RE: Modifications to Refuse  
Ponds, Wellington Coal  
Cleaning Plant  
ACT/007/012

Raise Upper Refuse Dike and North Dike  
Final Construction Plans

Re: Impoundment Modifications for Upper Refuge Dike  
and North Dike at Wellington Coal Cleaning Plant

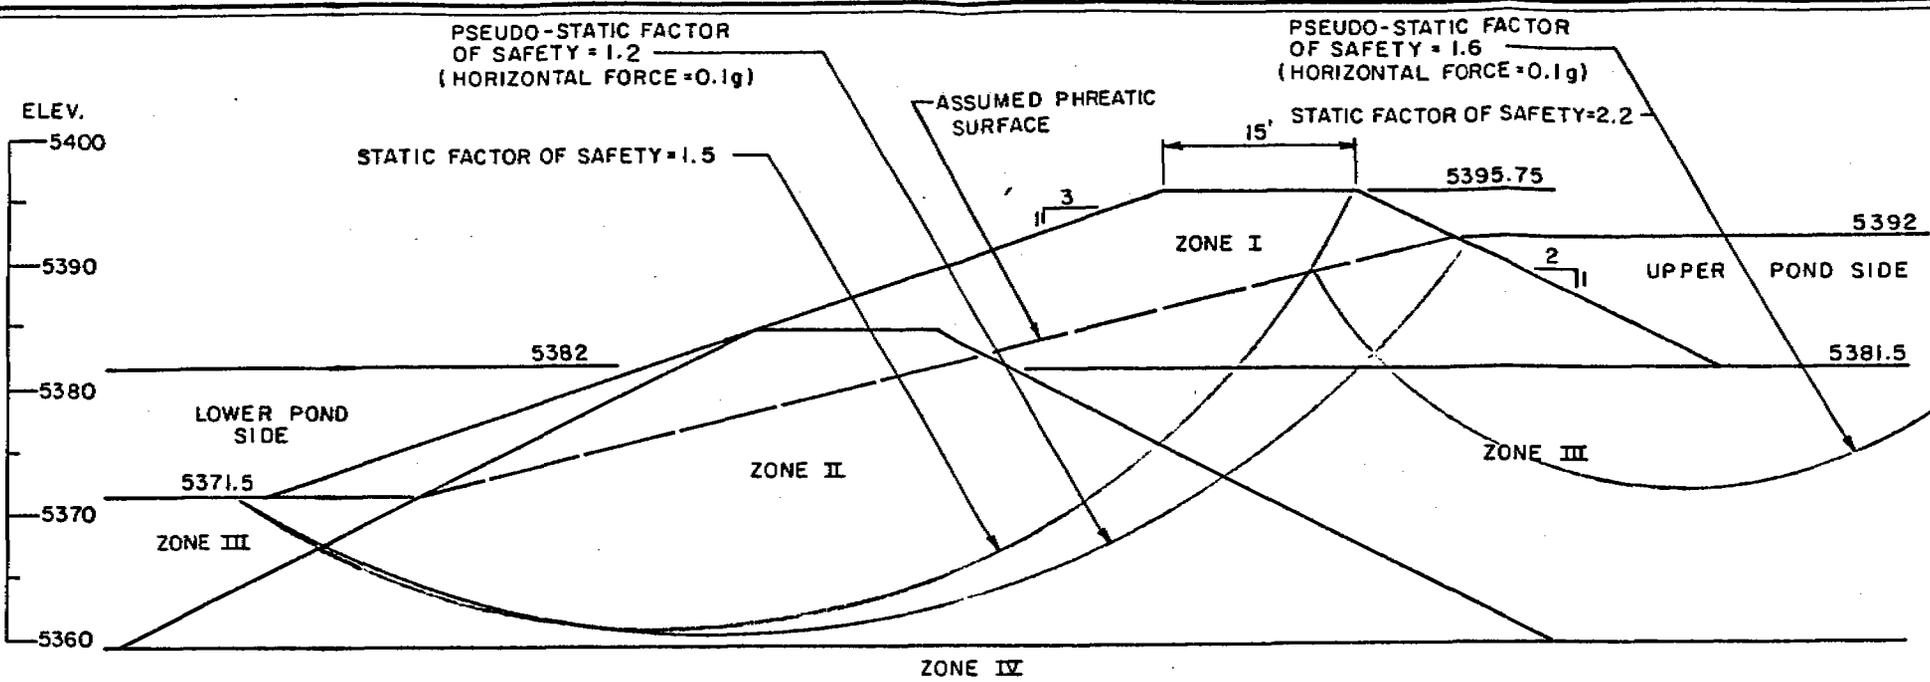
#### B. North Dike

The cross section for the North Dike is essentially the same as that shown in Figure No. 34 of the March 1983 report. During that report, the unit weight for the course coal refuge was assumed to be 94 pounds per cubic foot. During the construction of the Lower Refuge Dike in 1984, the average unit weight of the course coal refuge was 103 pounds per cubic foot. This value was used during the present analysis and it will be observed from Figure No. 2 that the static factor of safety was 1.8 compared to 1.9 during the 1983 analysis. The pseudostatic analysis applying horizontal force 0.1 g resulted in a factor of safety of 1.3.

FIGURE  
NO. 1

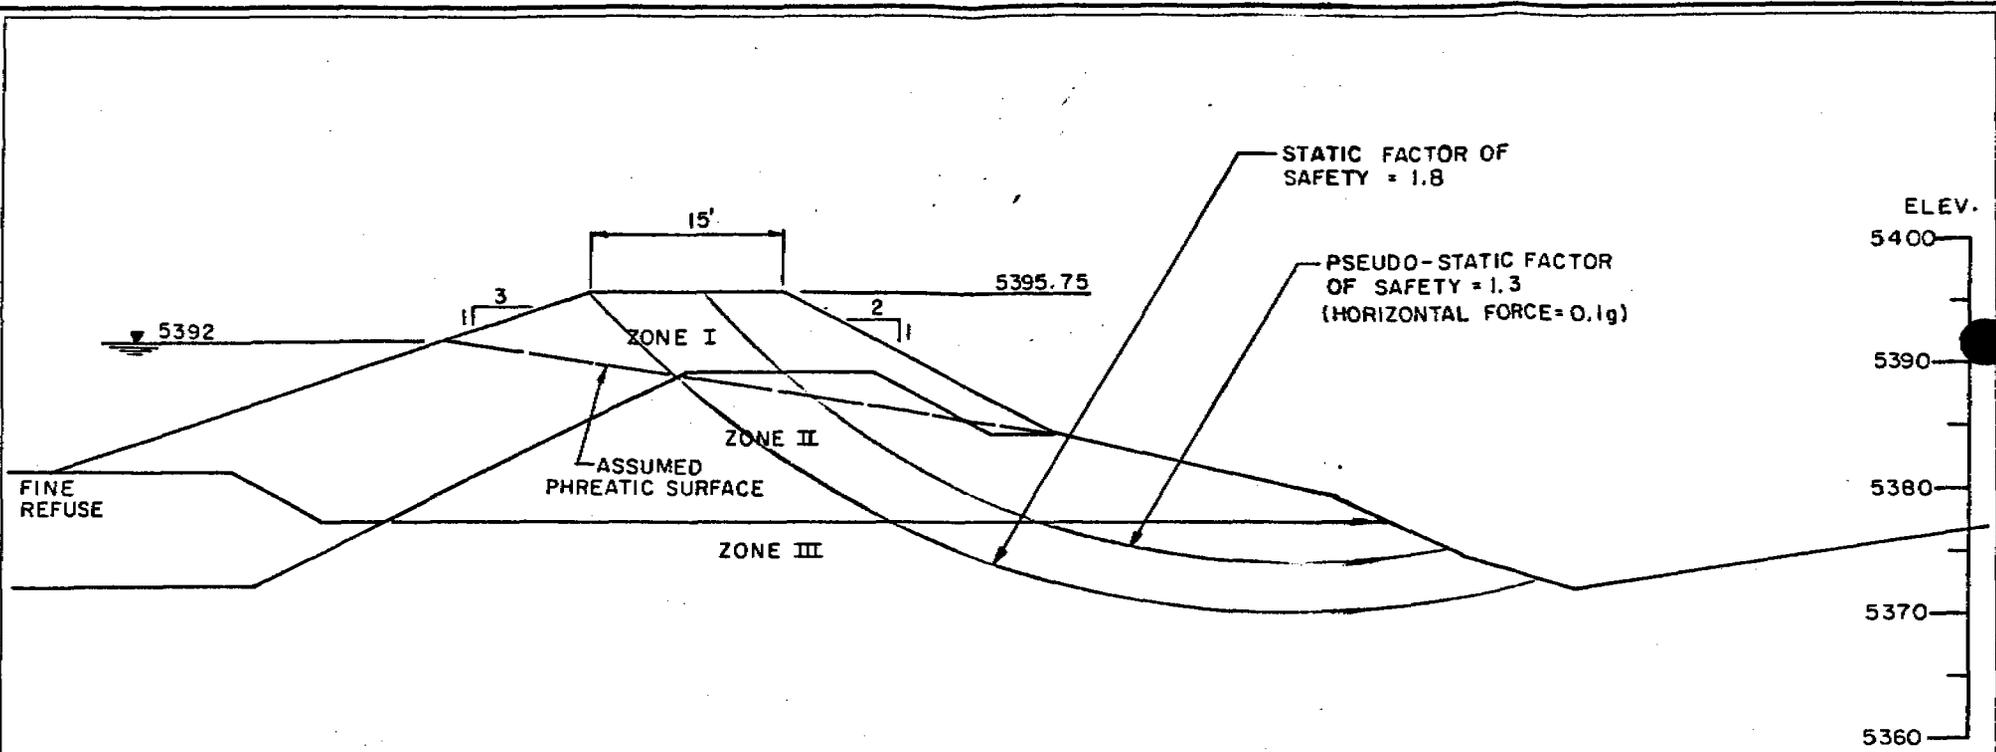
A. Upper Refuge Dike

The cross section shown on Sheet E9-3456 has been modified from the cross section on which the static stability analysis was performed in the March 1983 report. It will be observed from Figure No. 33, that the cross section analyzed had a side slope of two horizontal to one vertical on the lower refuge pond side and three horizontal to one vertical on the upper refuge pond

side. Sheet E9-3456 indicates a slide slope of three horizontal to one vertical on the lower refuge pond side and two horizontal to one vertical on the upper refuge pond side. It should be noted that the critical slope is the lower refuge pond side. Since the side slope has been flattened from two to one to three to one, the factor of safety for the static condition should increase from that shown in Figure No. 33 of the March 1983 report. A stability analysis was performed for the static condition for both the lower pond and the upper pond sides and the results of this analysis are presented in Figure No. 1 attached hereto. The stability analysis used effective stress parameters and was based on Bishop's Modified Method. The strength parameters are compatible with those used in the March 1983 report. It will be observed from this figure that a static factor of safety of 1.5 was obtained for the lower pond side while a factor of safety of 2.2 was obtained for the upper pond side. It should be noted that during the analysis for the upper pond side, the water level was assumed to be at elevation 5381.5. During the March 1983 report, no consideration was given to seismic stability for the Upper Refuge Dike. As indicated in the March 1983 report, the proposed facilities are located in Seismic Zone 2. The probability of a large intensity earthquake was relatively small. In order to obtain an indication of the effect of seismic activity a pseudostatic analysis has been performed. During this analysis for the Upper Refuge Dike, it will be observed from Figure No. 1 that a horizontal force of 0.1 g was applied and that factors of safety of 1.2 and 1.6 were obtained during the pseudostatic analysis. This approach indicates that a degree of safety exists for the dikes under seismic activity.
